Project No. 16074
March 10, 2021

**Subject: Response to Comments From Technical Advisory Committee
Woodbury Cooperative Site Improvements**

WOODBURY COOPERATIVE

SITE IMPROVEMENTS

SITE PLAN

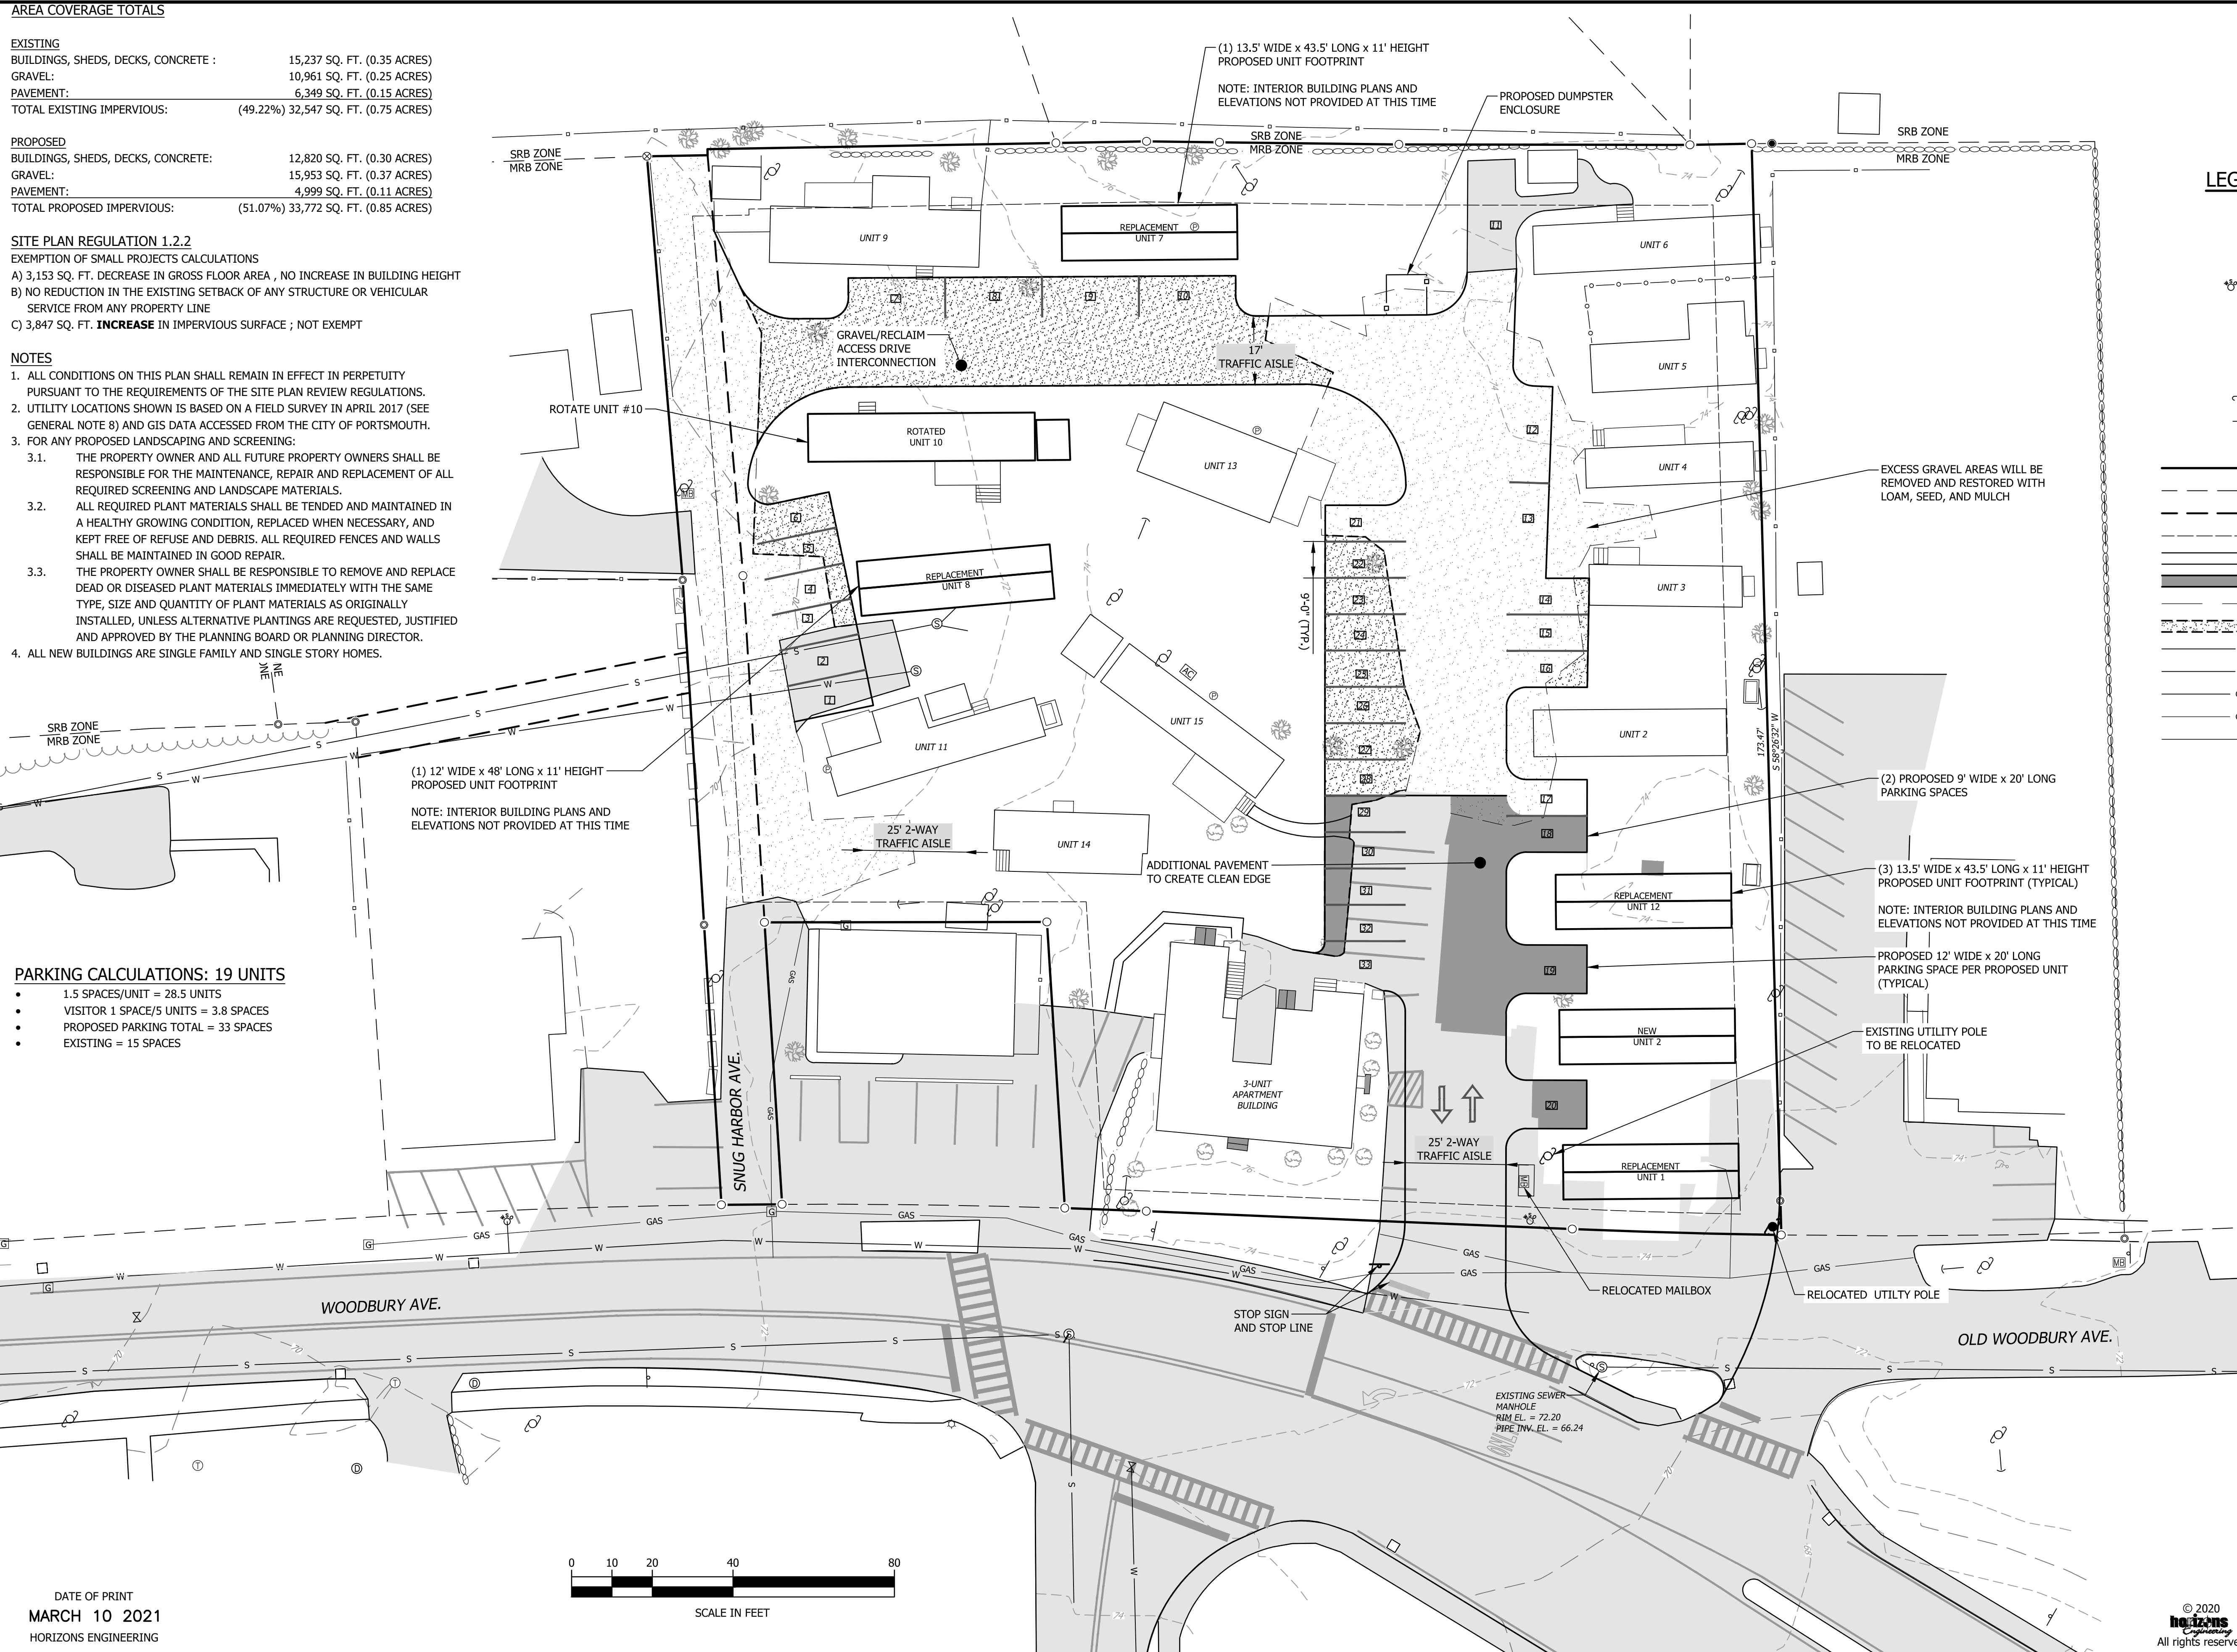
- 1. The pavement edge line should tie into the corner of the property at Old Woodbury Ave, rather than the edge of the abutter's driveway.**

- 2. A stop sign and stop line should be provided on the driveway approach to Woodbury Ave.**

- 5. The site plan is currently shown removing a small amount of asphalt paving on lot 237/71. Do you have permission to do that?**

We agree with this comment. The changes have been made to the site plan (Sheet 3).

We agree with this comment. The changes have been made to the site plan (Sheet 3) and a detail has been added to Sheet 8.

Changes have been made to the pavement cut so that no work will take place on lot 237/71.

UTILITY PLAN

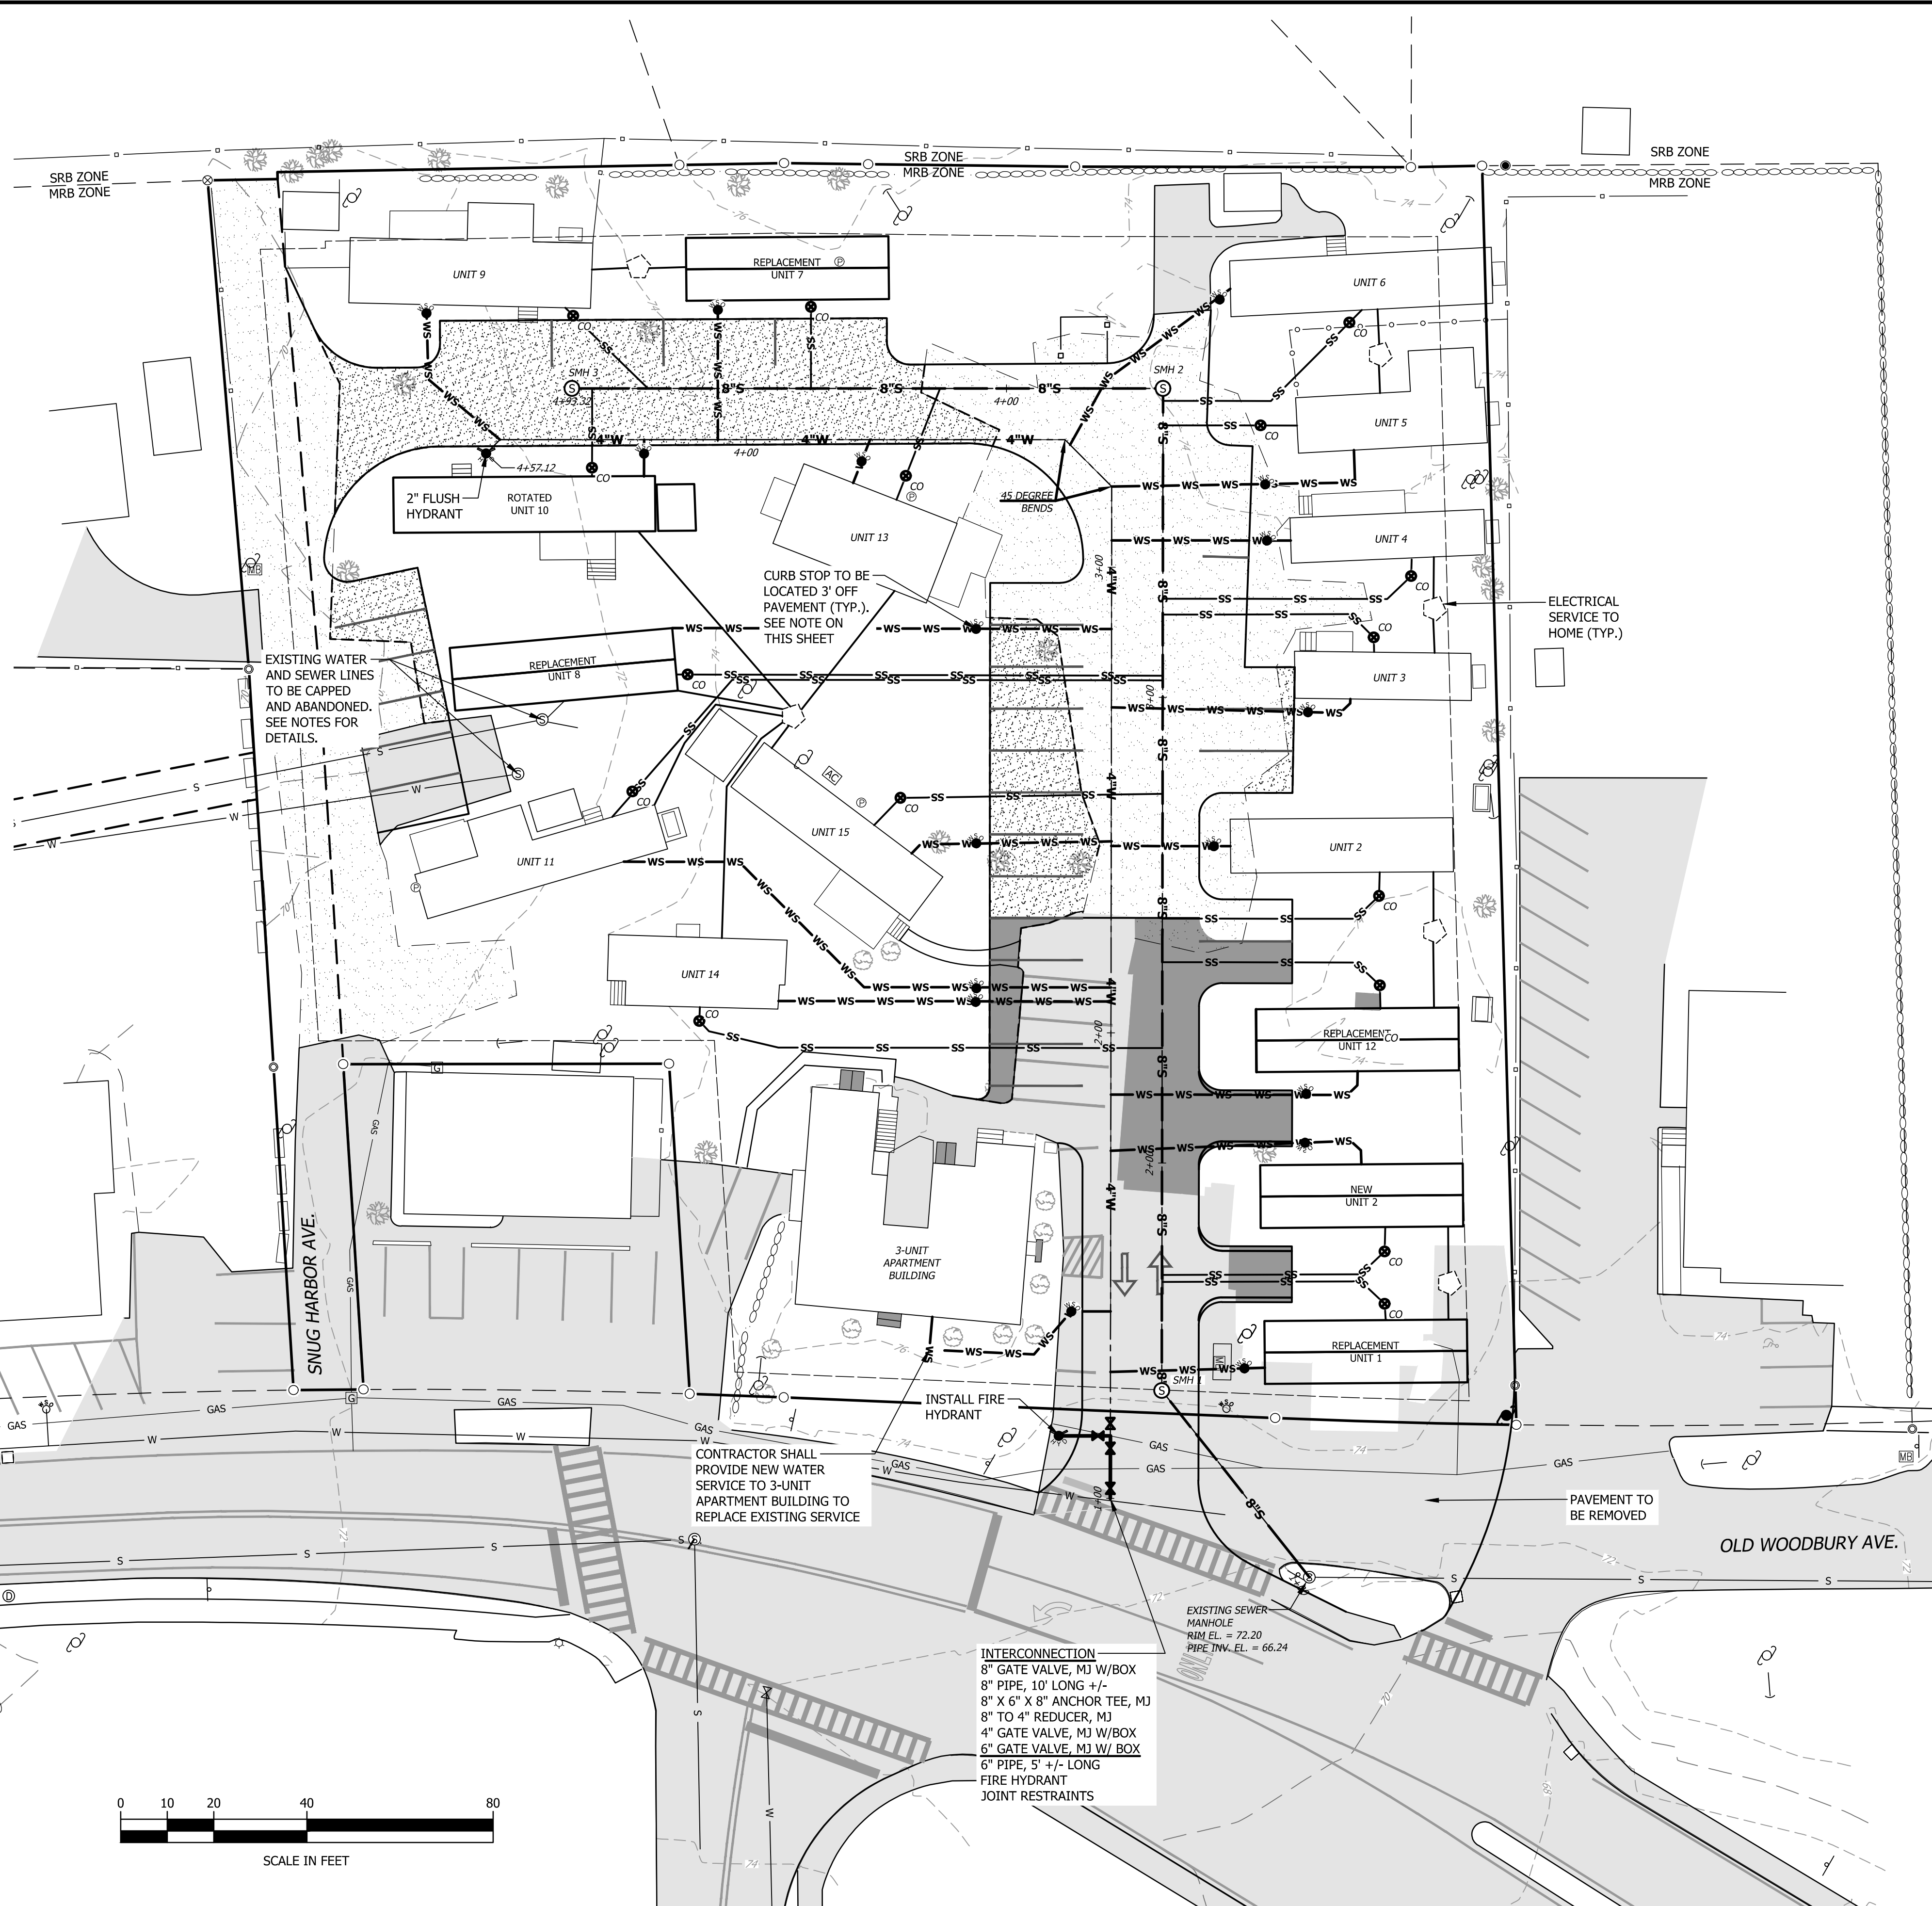
- 6. Sewer connections to the City system need to be witnessed by Portsmouth Sewer. The entire system must be tested to ensure the system is tight with no groundwater leaks to the satisfaction of the City.**

- 7. Work in the Portsmouth ROW's will require excavation permits. As previously stated, the City may provide some assistance with the work on old Woodbury Ave a formal request needs to be submitted.**

- 8. There is no water shut off shown for unit 13 or the apartment building.**

- 9. The 8" water main entering site should be downsized immediately following the hydrant connection. The hydrant needs its own 6" gate xv valve (please show it) on the hydrant lateral. The 4" valve should be mounted directly behind the hydrant tee.**

Notation has been added to the plans on Sheet 4 Water and Sewer Construction Notes 10 and 11.

Notation has been added to the plans on Sheet 4 Water and Sewer Construction Note 12.

This has been corrected. Both shut offs are shown on Sheet 4.

This change has been made to Sheet 4.

FLUSH VALVE DETAIL

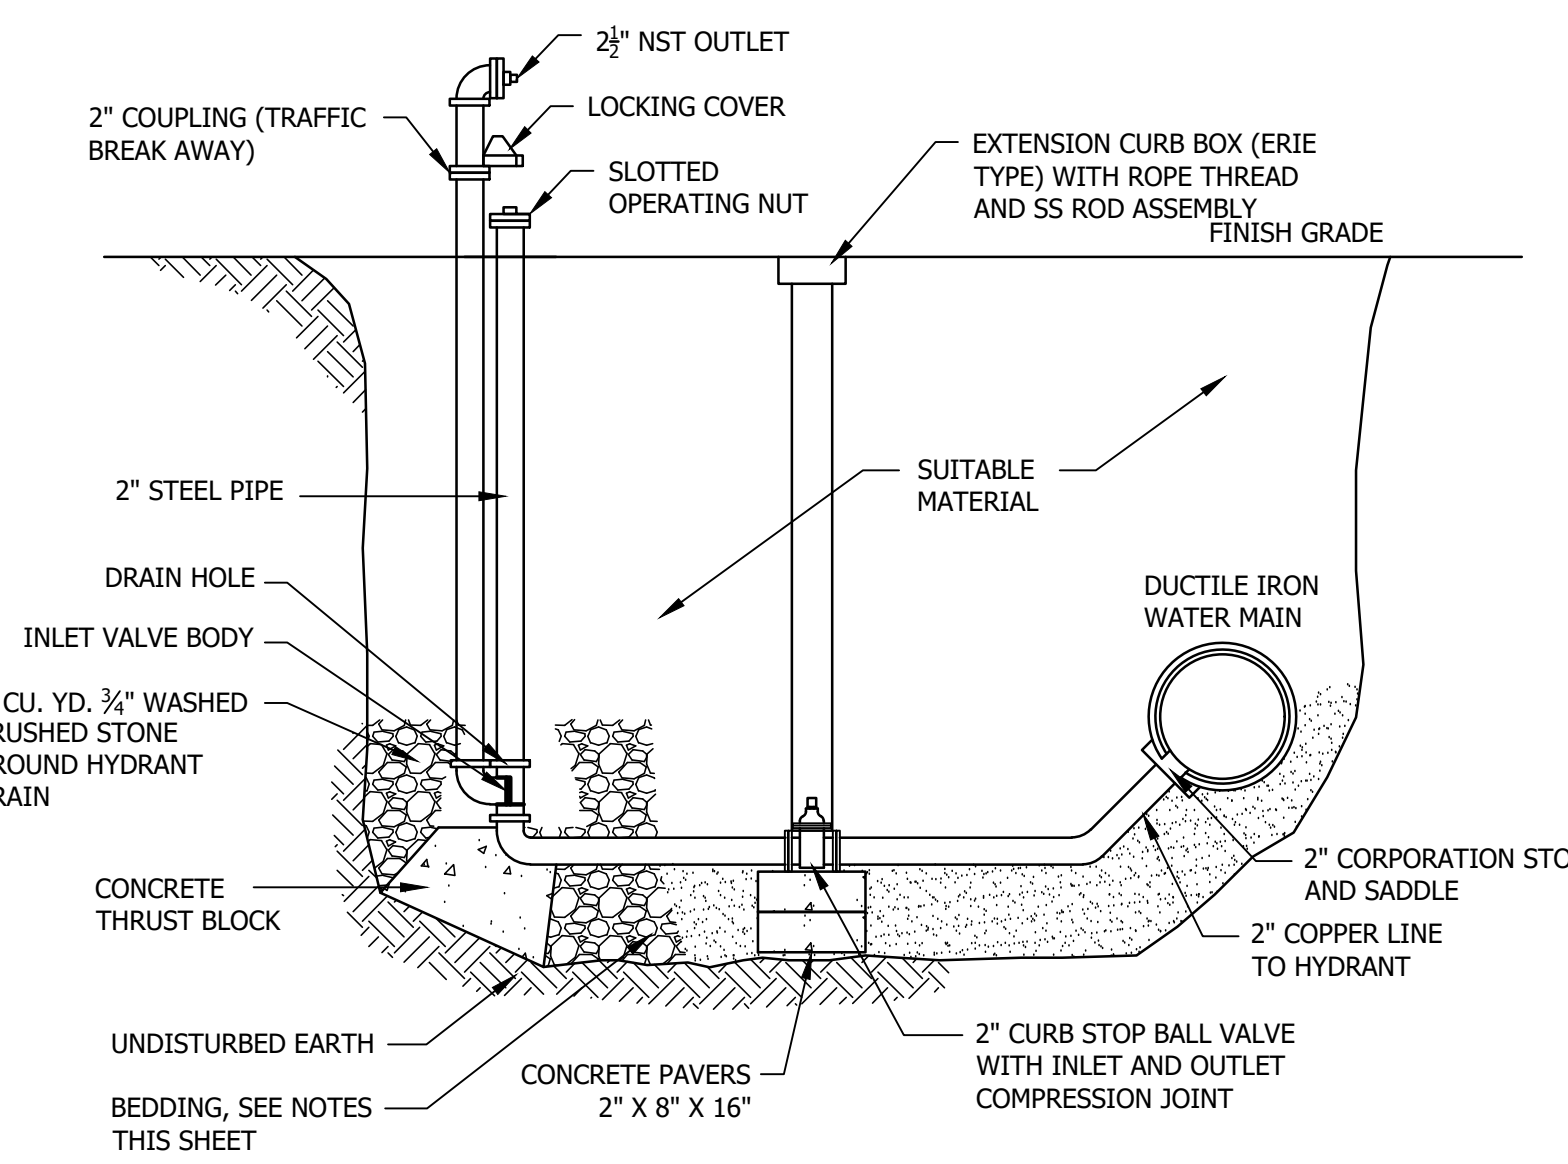
- 10. Flush valve detail references an 1.5" corporation in the main. 2" corporation with 2" copper water line to hydrant.**

This change has been made to Sheet 5.
